ADDENDUM NO. 3

BID CALL NO. T2021-173

CONSTRUCTION OF FIRE STATION 201 AT 25 RUTHERFORD ROAD SOUTH

2 Site Plan Vehicle Sweep & Existing Markings
1 : 500

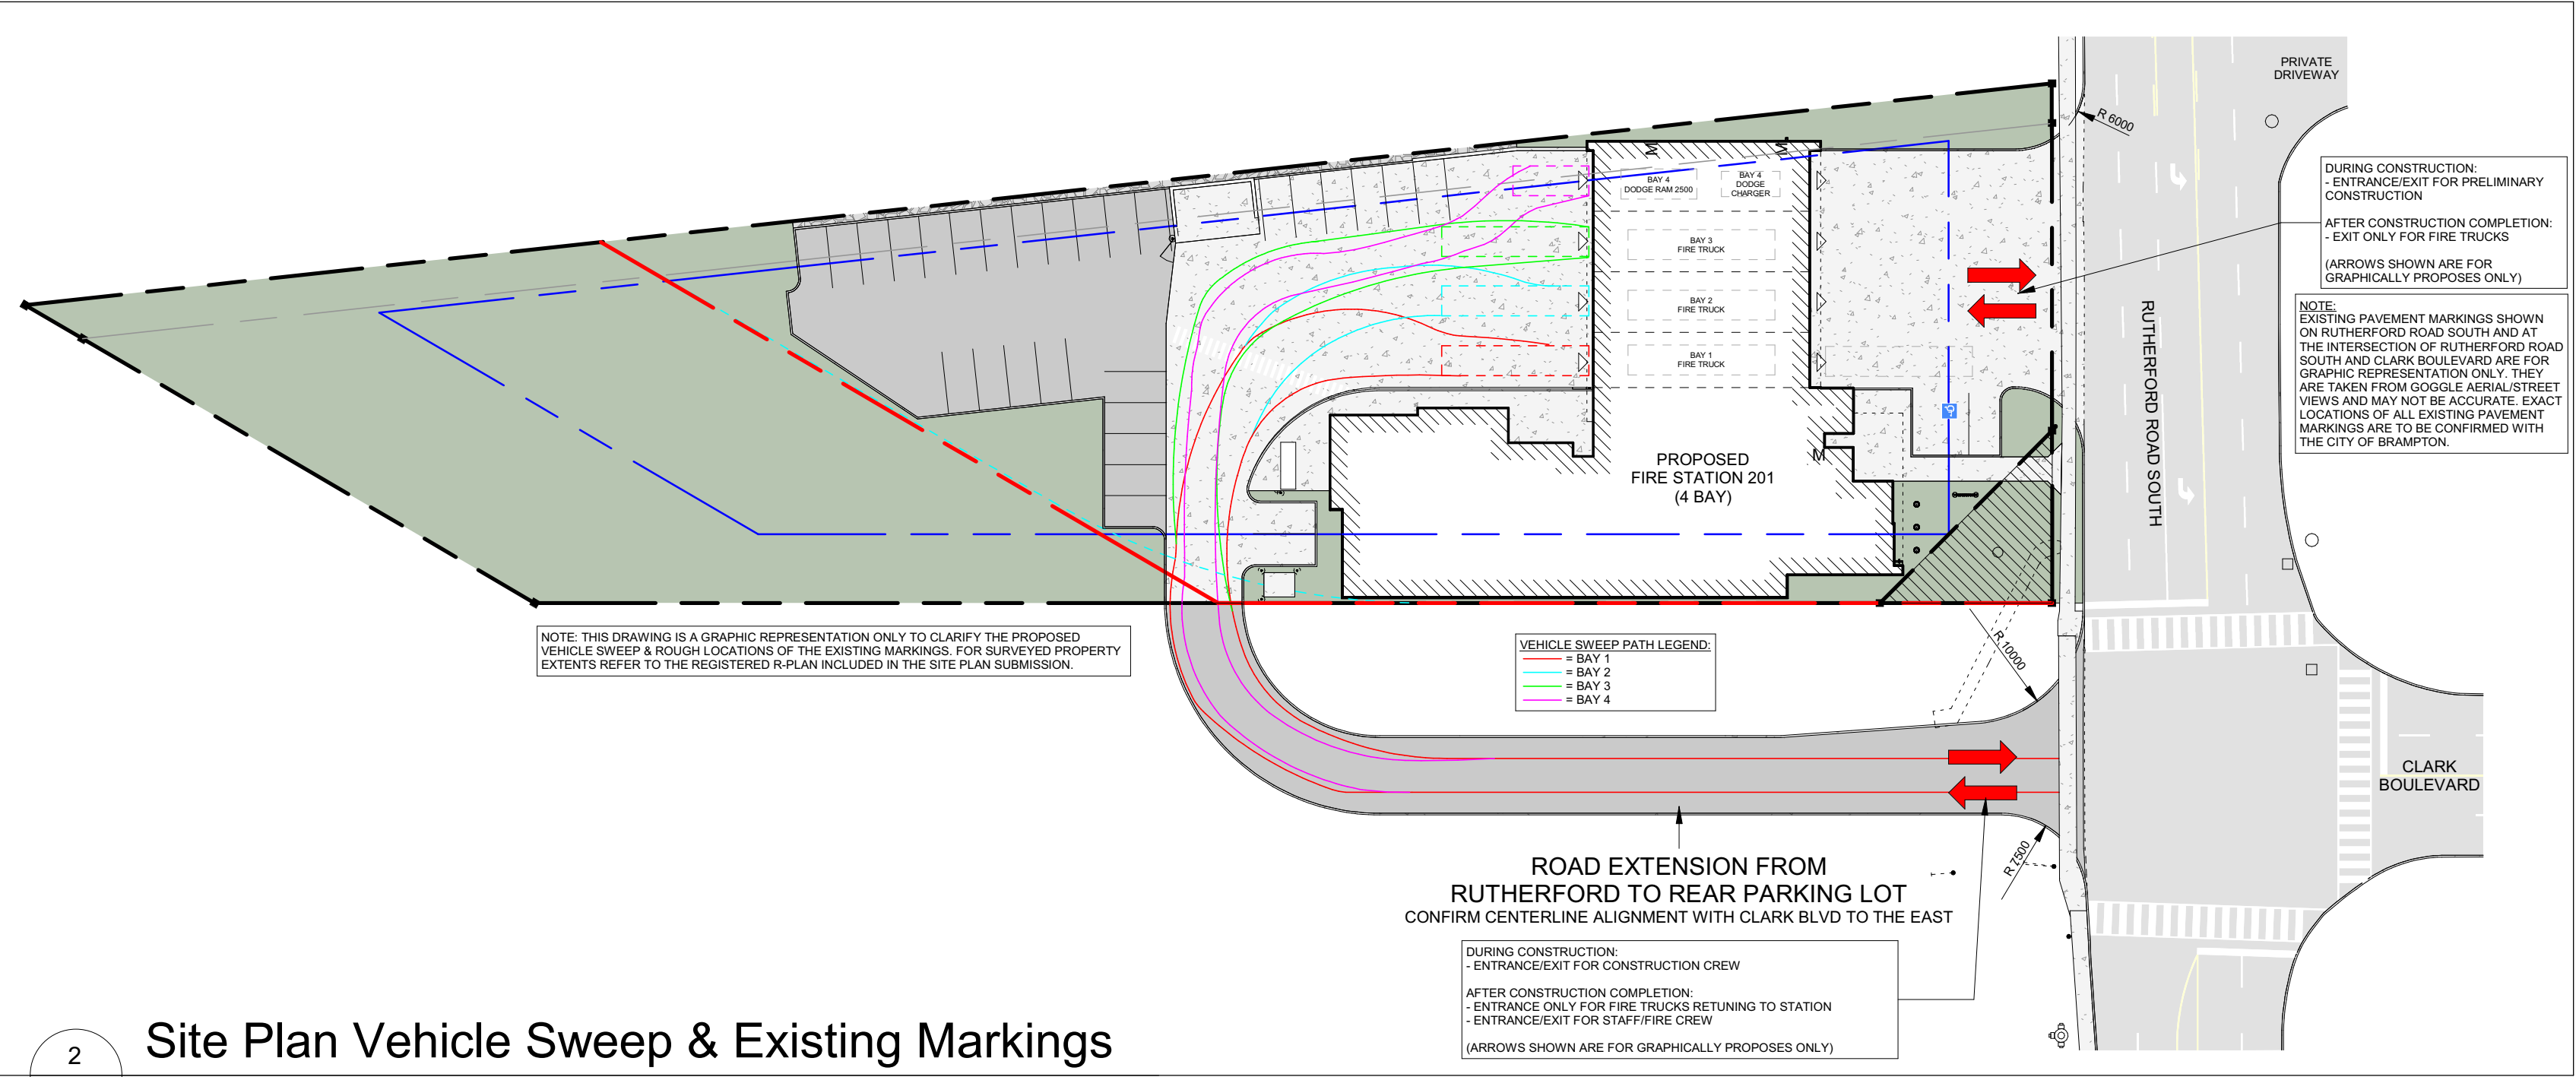
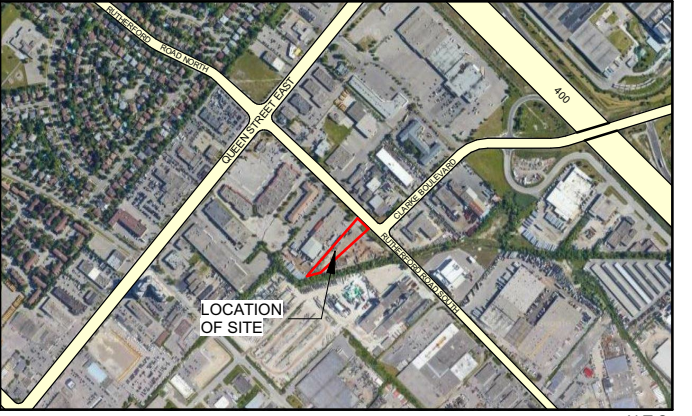
"A101, Fig 2. Please confirm the proposed DO NOT STOP signage and pavement markings in front of the firestation station are to be included within the contract scope of work as no further details were provided in the documents.

A101, Fig 2. Please confirm the proposed STOP WHEN FLASHING overhead traffic signs are to be included with the contract scope of work as no further details were provided in the documents.

A101, Fig 2. Please confirm any electrical connection to the proposed STOP WHEN FLASHING overhead traffic signs is not included in this contract. Electrical drawings do not show any of this work."

Response: Refer to the revised site plan drawing A101. References to these markings and signals have been removed. These are out of the scope of this contract.

1 Level 1 Floor Finishes Plan
A600 1 : 100

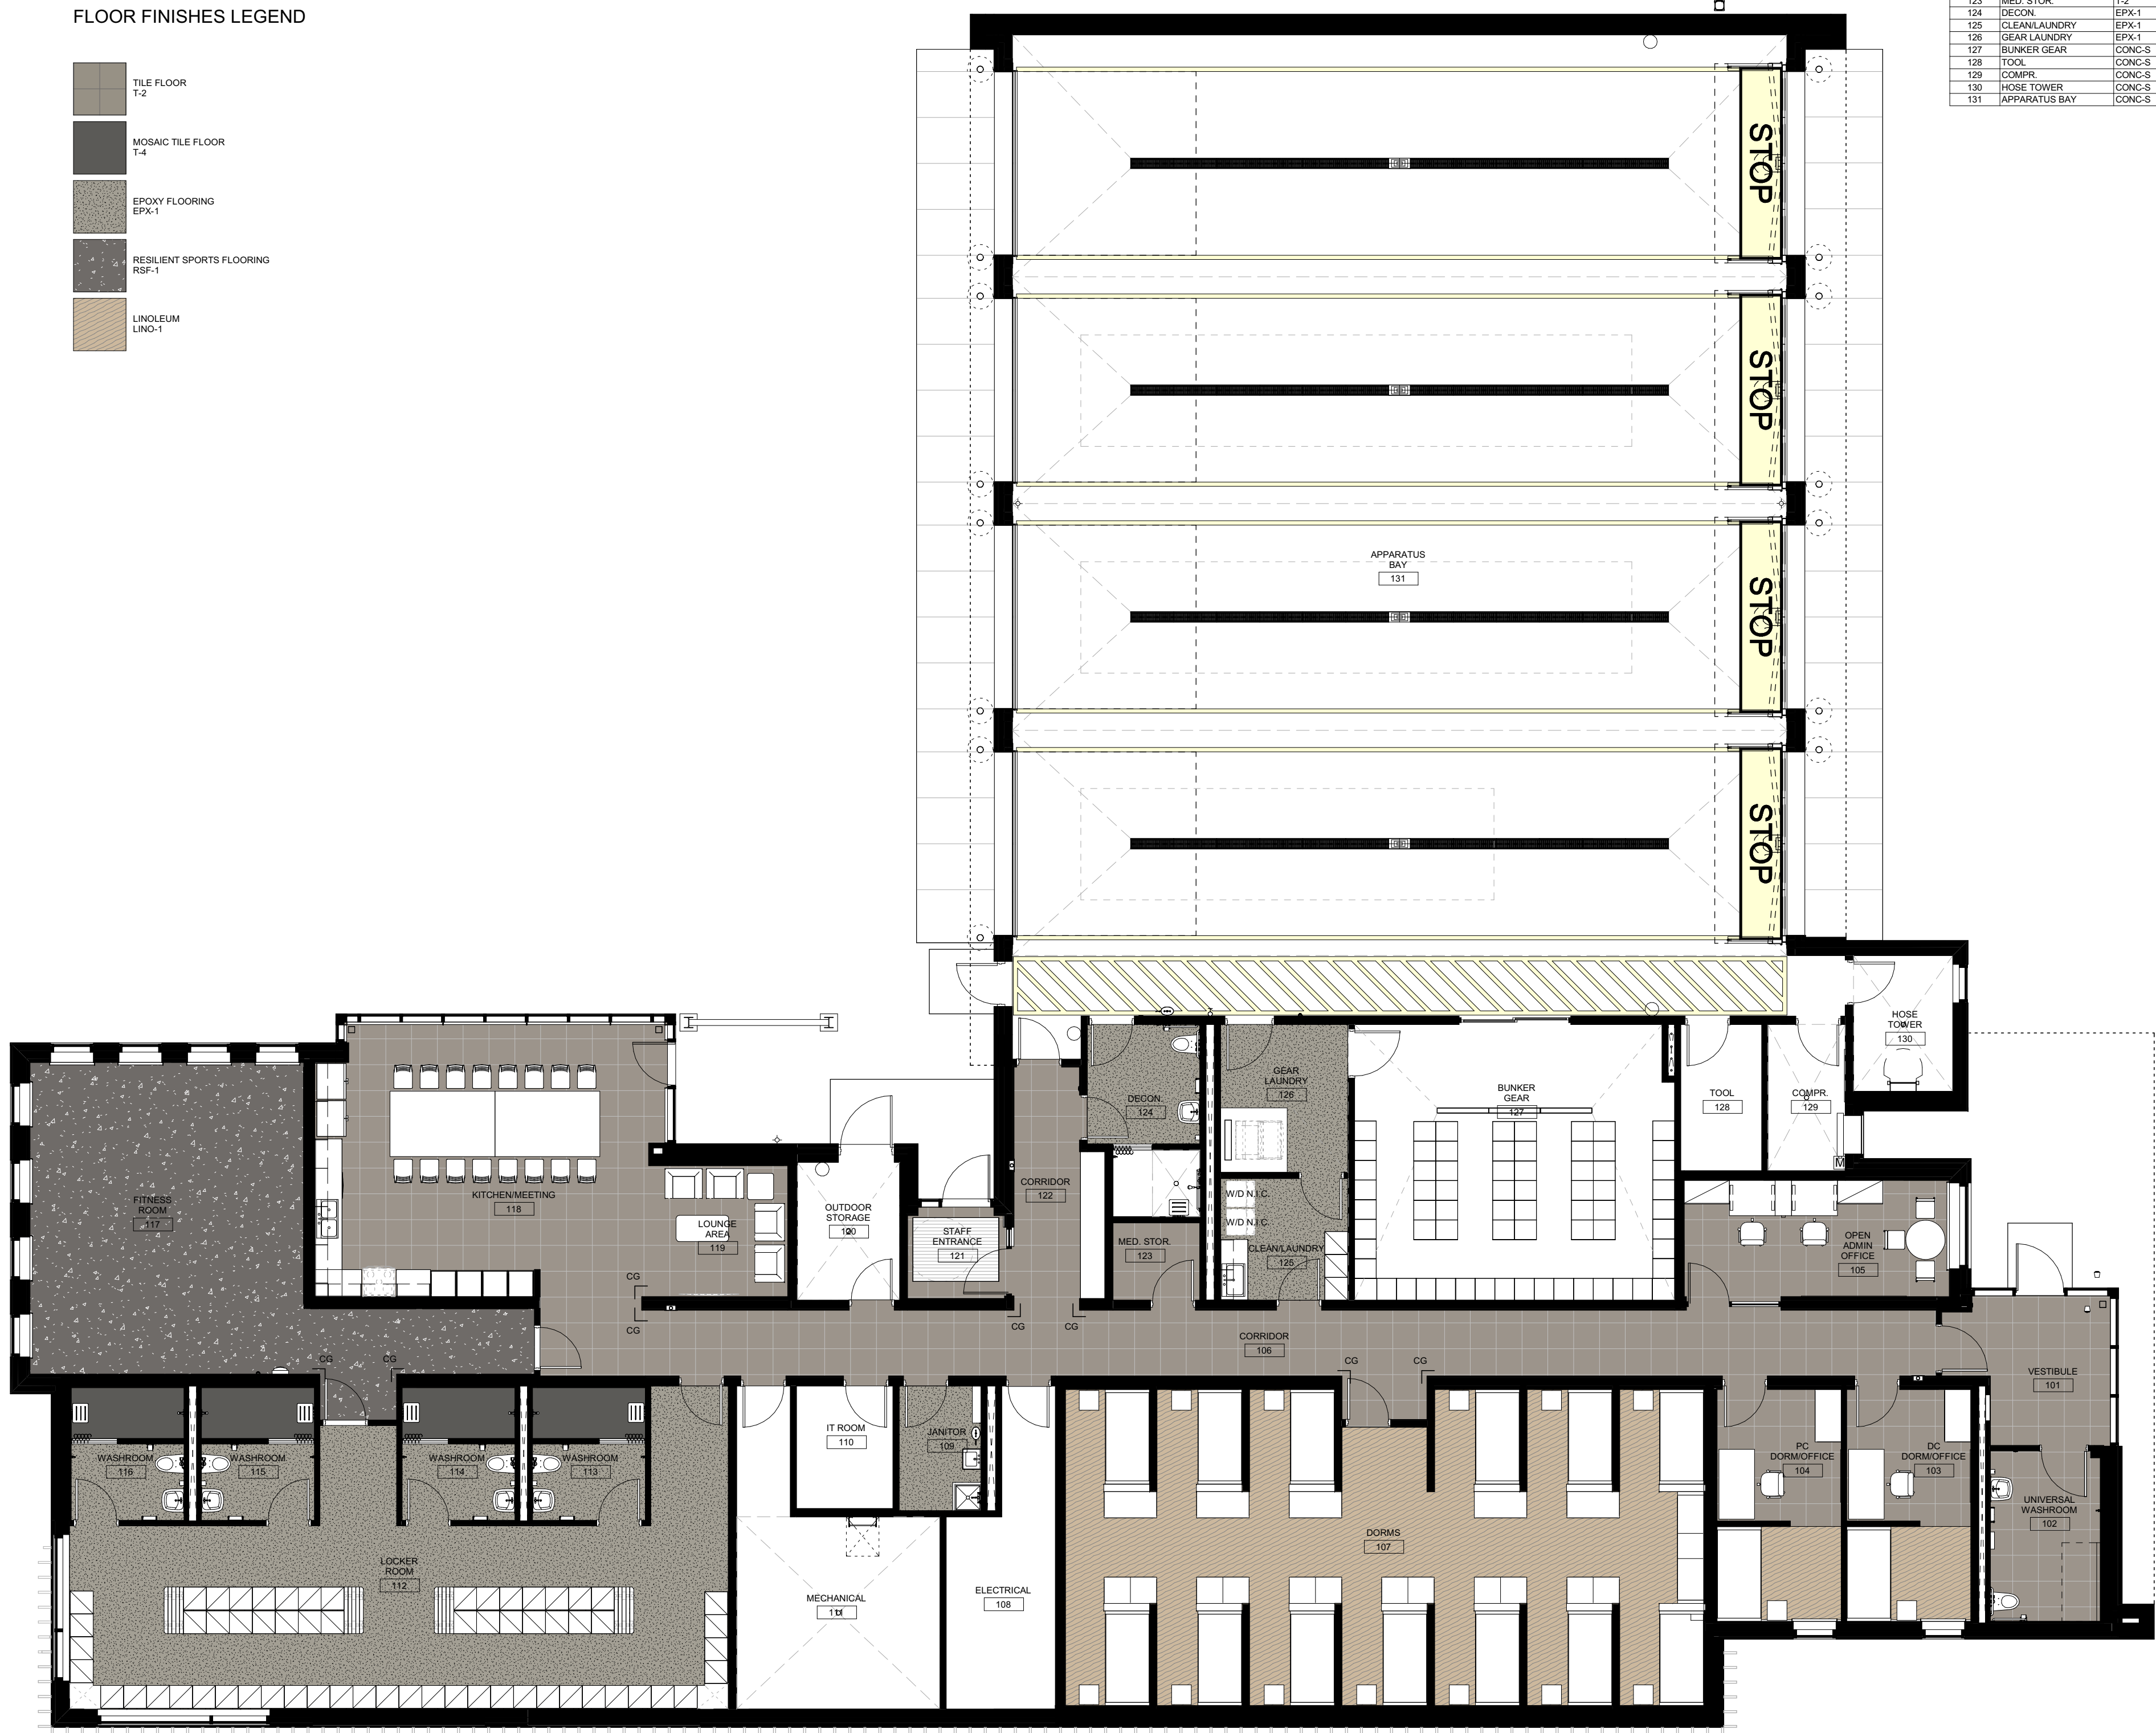
"Could you please clarify where the Fibreglass Reinforced Plastic Cladding is to be installed? There is no shown in the Room Finish Schedule.

"The Room Finish Schedule, A600, is incomplete for several rooms. Please provide a complete schedule.

"At the Apparatus Bay, is the exposed ceiling or exposed underside of deck (along with attached Mechanical/Electrical items) to be painted? This is not mentioned in the spec or the drawings, however as this is a large area, please confirm.

"Specifications 05 50 00 and 10 80 00 both identify different types of corner guards for the project. However none are shown on the drawings nor noted where to be used per the specs. Please confirm both are to be used on the project and their respective locations."

"Please advise where the FRP Wall Cladding is located. None is shown on the drawings and locations have not been identified in the specification."

Response: Refer to the revised Room Finish Schedule on sheet A600 included in this addendum.

Response: Refer to the revised Room Finish Schedule on sheet A600 included in this addendum.

Response: Refer to the revised Room Finish Schedule on sheet A600 included in this addendum.

Response: Corner guards are to be per spec section 10 80 00. Refer to drawing A600 issued as part of this addendum for locations. There are 8 locations.

Response: Refer to the revised Room Finish Schedule on sheet A600 included in this addendum.

LEVEL 1 PLAN - POWER & SYSTEMS

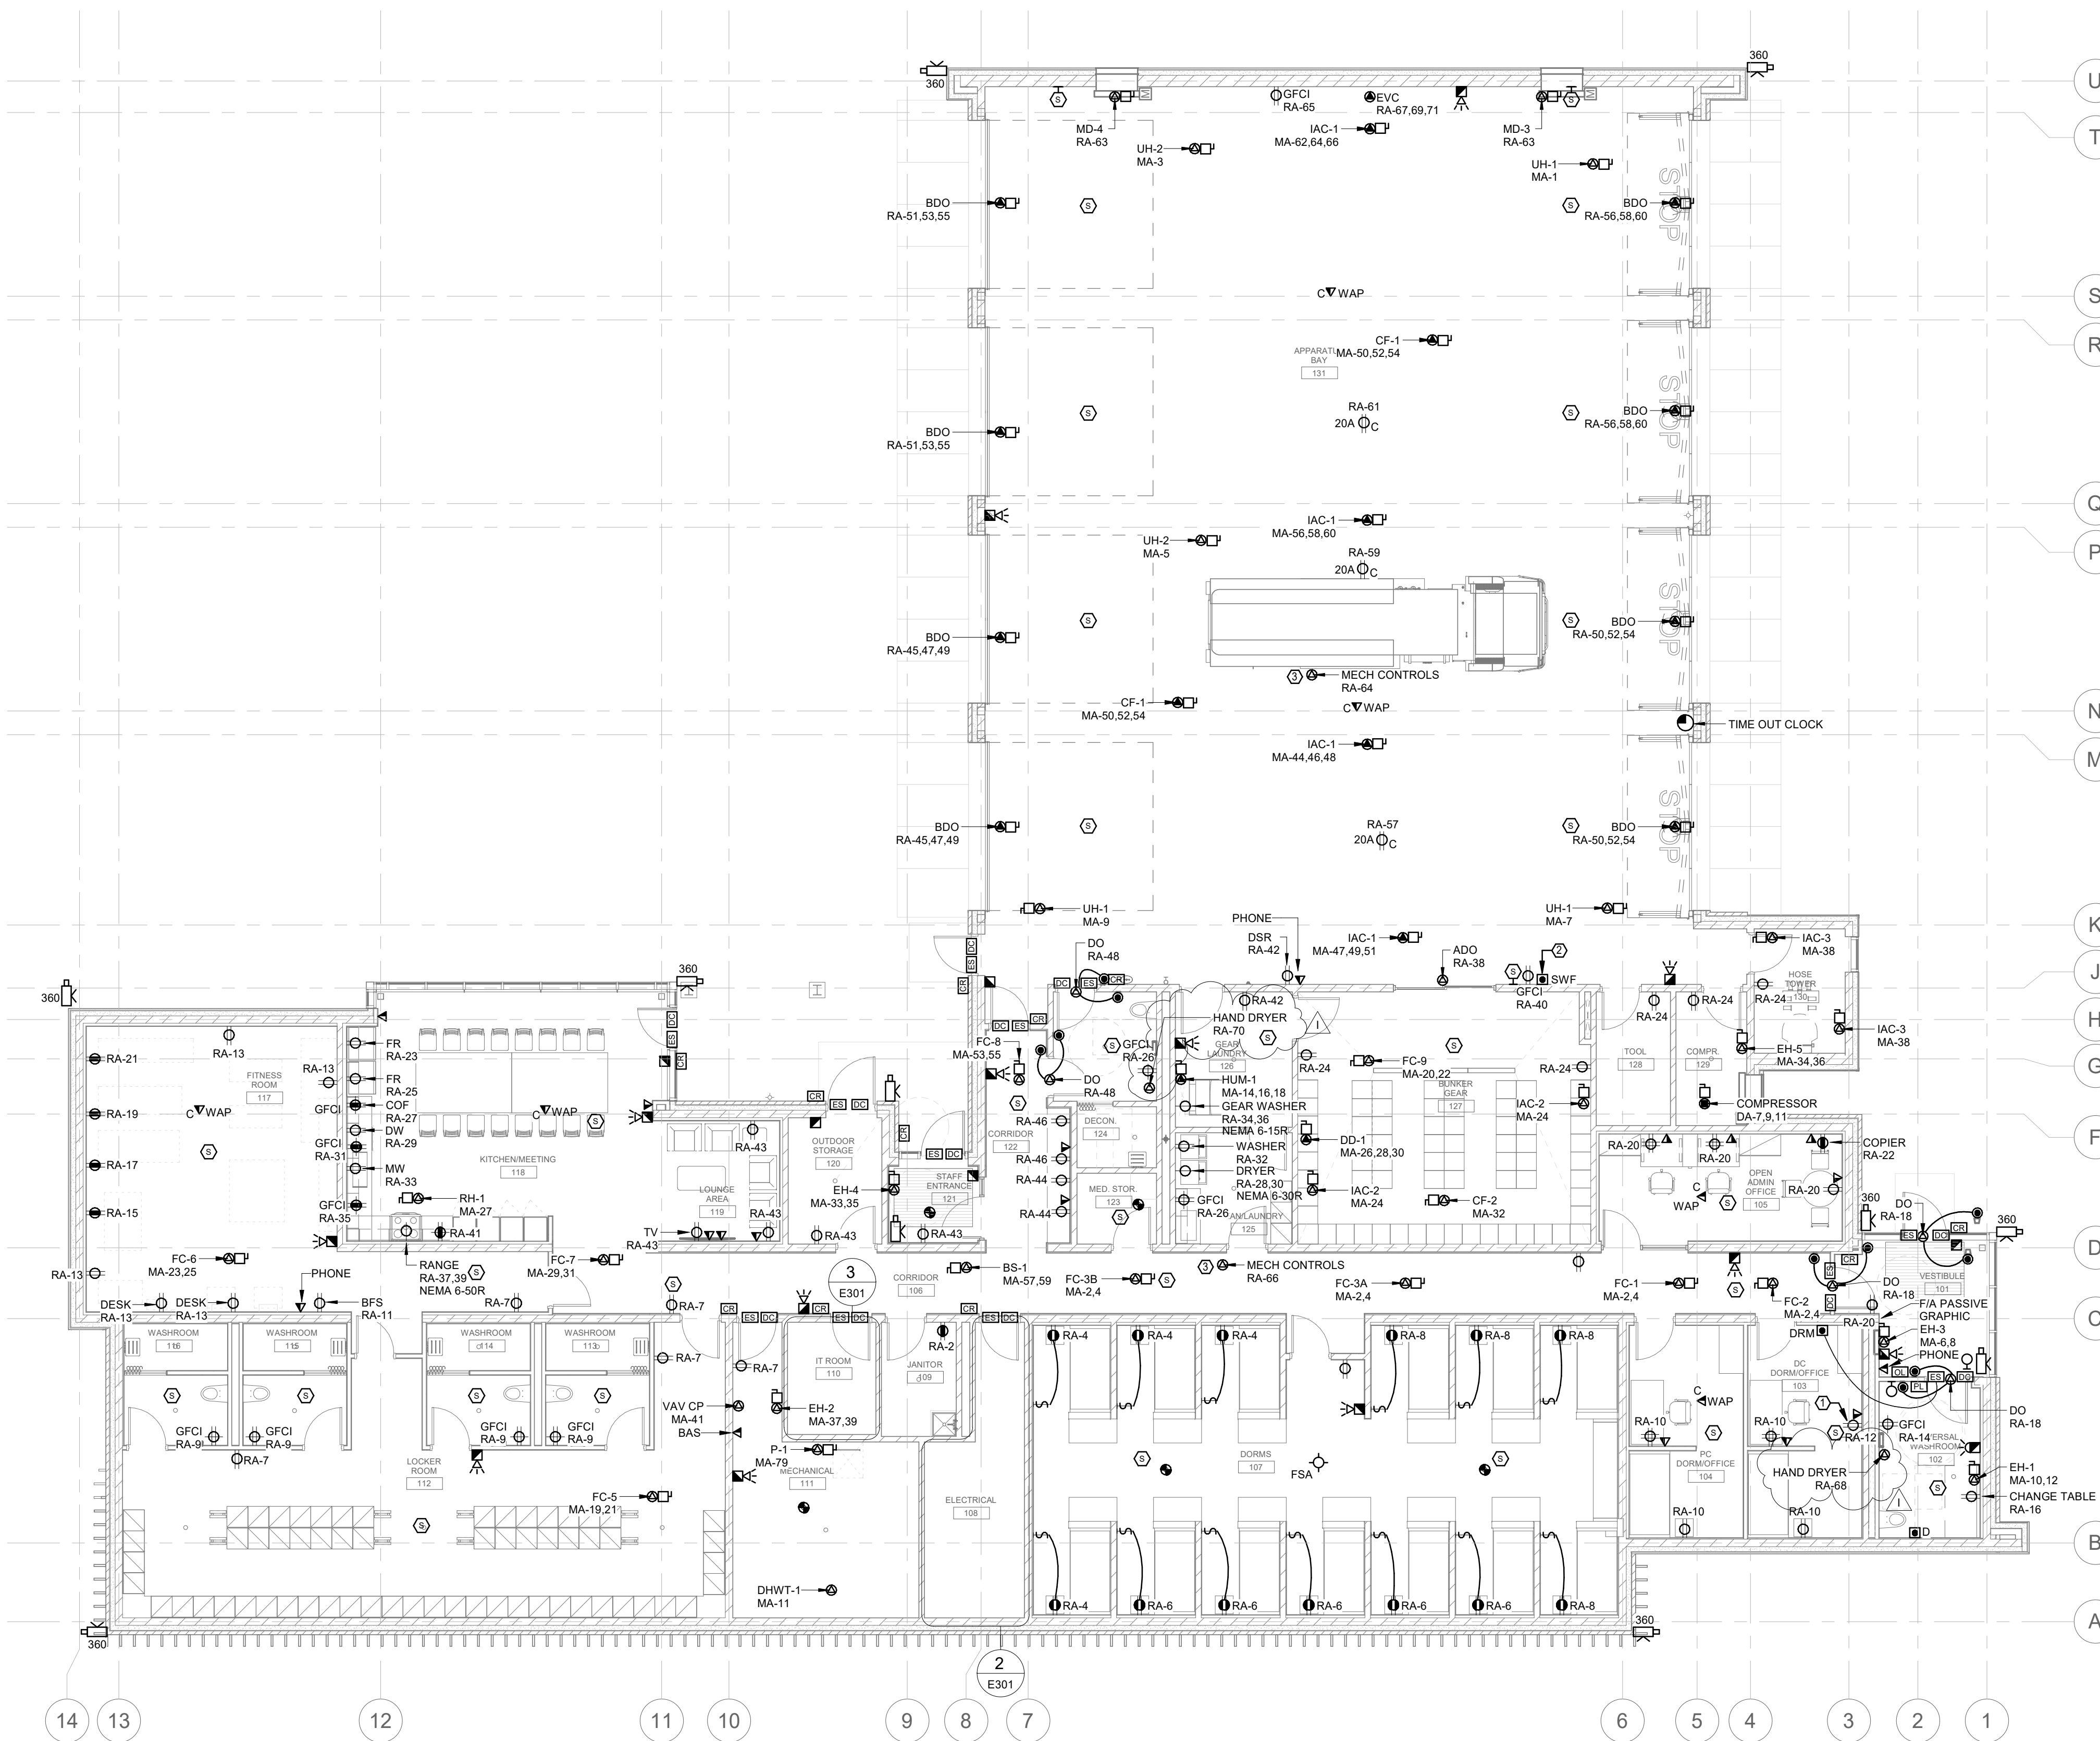
1. **Drawing E301 – Level 1 Plan – Power & Systems**
 - a. Add hand dryer connection in Universal Washroom 102.
 - b. Add hand dryer connection in Decon 124
2. **Detail 1/E501 – Single Line Distribution Diagram**
 - a. Revise drawing to add neutral conductor for incoming service.
 - b. For SPD (Surge Protective Device), delete 30A/3P breaker and add 60A/3P breaker. Revise feeder as noted to suit.
3. **Drawing E601 – Electrical Schedules (1)**
 - a. Lighting fixture schedule, add note 1: "Substitute manufacturers in accordance with Section 26 50 00."
4. **Drawing E603 – Electrical Schedules (3)**
 - a. Add two 20A/1P GFI breakers on circuits RA-68 and RA-70 to feed hand dryers.
 - b. Add 7 x 15A/1P and 3 x 20A/1P spare breakers to panelboard RA.
